Office Action Summary

10/789,597

DETAILED ACTION

Bayles, Figure 2

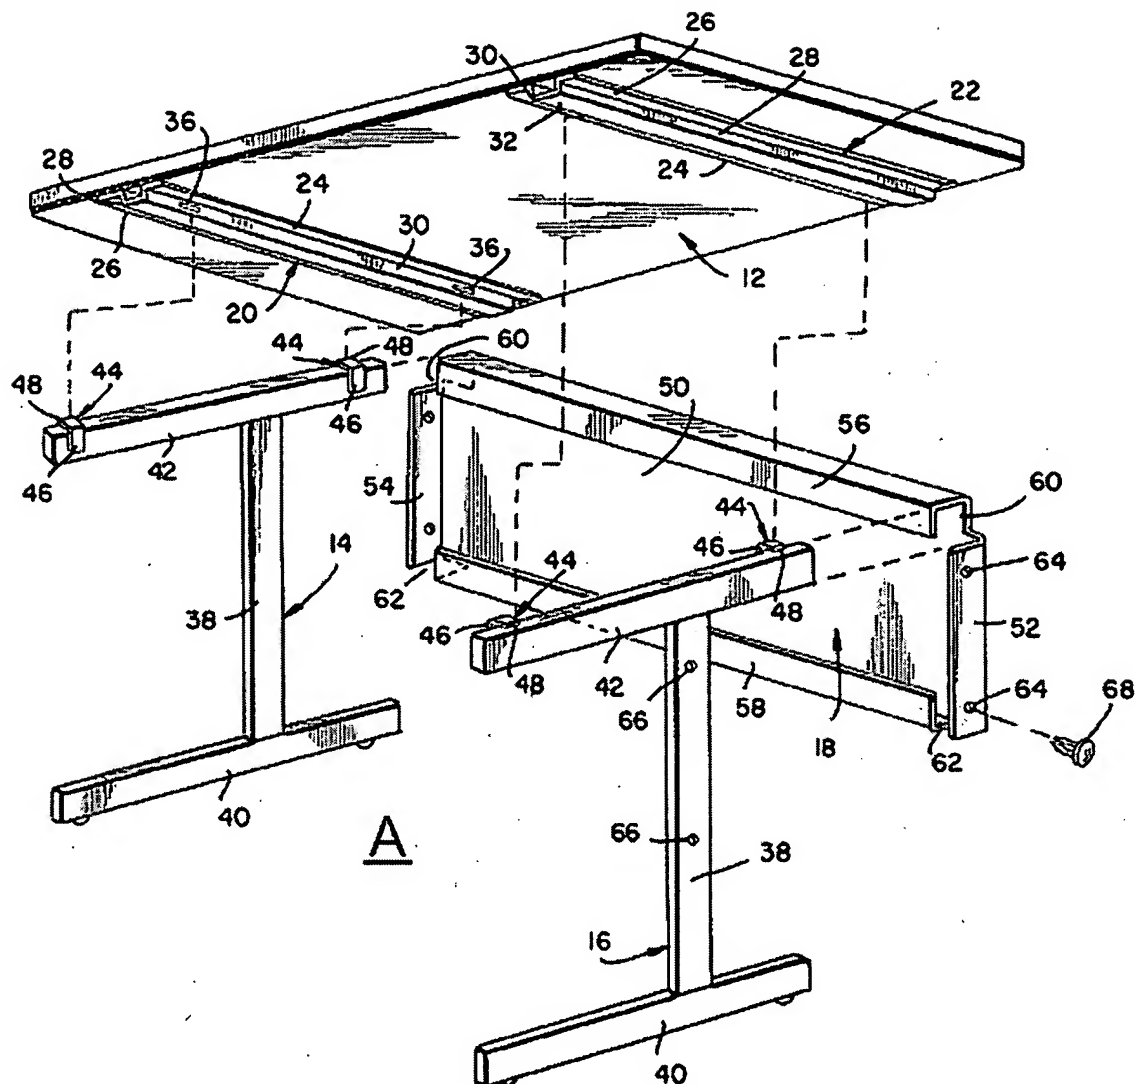
a. Regarding Claim 1, Bayles teaches a privacy screen (18) for use within a desk assembly having a worksurface (12) and an open span (A, best seen in Bayles, Figure 2) located below the worksurface comprising a first member (18) having a generally planar first portion (best seen in Bayles, Figure 2), a first flange (58) extending longitudinally along the first planar portion, and a first end

(52) and a second end (54) adapted to be secured to a desk assembly within an open span (A) located below a worksurface (12) of the desk assembly. Bayles does not teach a telescopically adjusting second portion of the privacy screen. Diamond et al. teach a panel having two members (20, 22), the first member (22) having a generally planar first portion (best seen in Diamond et al., Figure 1), a first flange (36) extending longitudinally along the first planar portion and a second member (20) having a generally planar second portion (best seen in Diamond et al., Figure 1), a second flange (32) extending longitudinally along the second planar portion and configured to telescopically receive the first flange of the first member therein such that planar second portion is substantially proximate the planar first portion thereby allowing adjustment of an overall length of the panel extending between the first end and the second end. It would have been obvious to one of ordinary skill in the art at the time of invention to modify the device of Bayles by using a telescopically adjusting panel as taught by Diamond et al. in order to allow the user to mount the panel on a diverse selection of desks with different span sizes.

- b. Regarding Claim 2, Bayles further teaches that the first flange (58) is substantially C-shaped (best seen in Bayles, Figure 2).
- c. Regarding Claim 3, Diamond et al. further teach that the first flange (36) includes a first portion (B) extending from and substantially orthogonal to the first

Diamond, et al., Figure 2

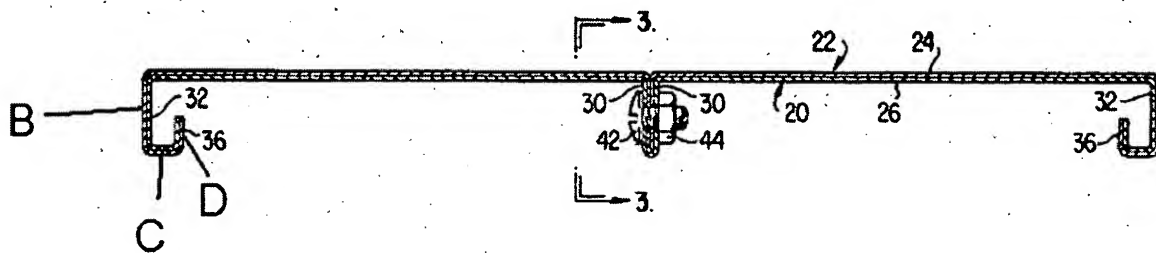
planar portion, a second portion (C) extending from and substantially orthogonal to the first portion, and a lip portion (D) extending from the second portion and towards the first planar portion. It would have been obvious to one of ordinary skill in the art at the time of invention to modify the device of Bayles by using a flange with three portions as taught by Diamond et al. in order to allow the panel to be folded into shape.

d. Regarding Claim 4, Diamond et al. further teach that the second flange (32) is substantially C- shaped (best seen in Diamond et al., Figure 2). It would have been obvious to one of ordinary skill in the art at the time of invention to modify the device of Bayles by using a C-shaped second flange as taught by Diamond et al. in order to more securely fit into the receiving portion of the first flange.

Diamond et al., Figure 2 (Detail)

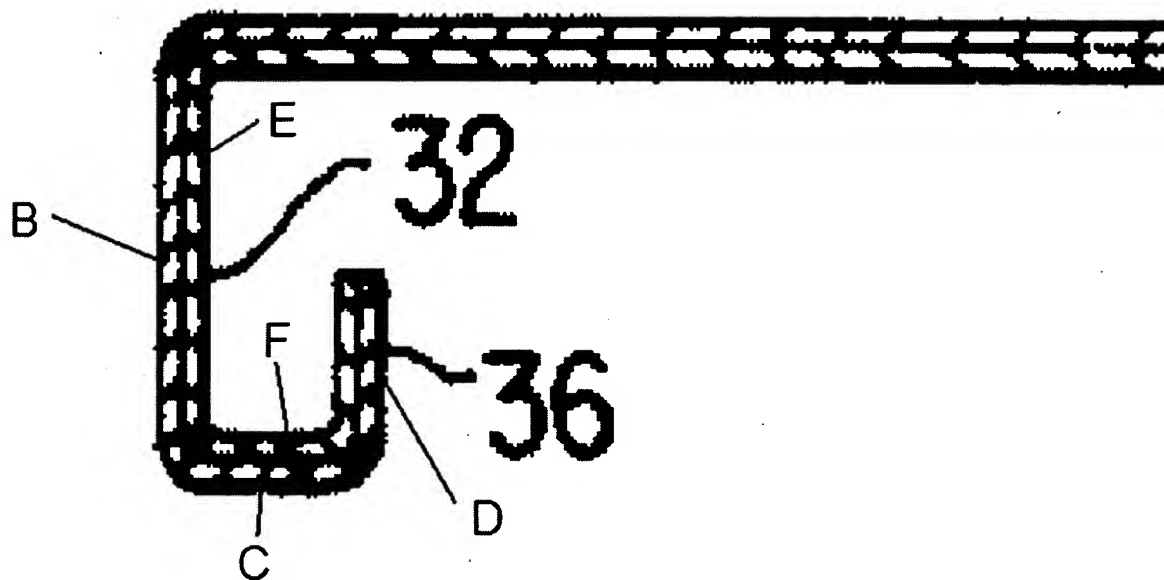
e. Regarding Claim 5, Diamond et al. further teach that the second flange (32) includes a first portion (E, best seen in Diamond et al., Figure 2 Detail, below) extending from and substantially orthogonal to the second planar portion and a second portion (F) extending from and substantially orthogonal to the second portion of the second flange, and wherein the second portion (F) of the second flange is telescopingly received between the second portion (C) of the first flange and the lip portion (D) of the first flange (Note: the second portion of the second flange is considered received by the first flange as it resides in the space defined by the second portion and the lip portion). It would have been obvious to one of ordinary skill in the art at the time of invention to modify the device of Bayles by using a two-portion second flange as taught by Diamond et al. in order to allow the panel to be folded into shape.

p. Regarding Claim 16, Diamond et al. further teach that the second flange (32) of the second member (20) includes a first portion (E, best seen in Diamond et al., Figure 2 Detail, above) extending from and substantially orthogonal to the second planar portion and a second portion (F) extending from and substantially orthogonal to the second portion of the second flange, and wherein the second portion (F) of the second flange is telescopingly received between the second portion (C) of the first flange and the lip portion (D) of the first flange (Note: the second portion of the second flange is considered received by the first flange as
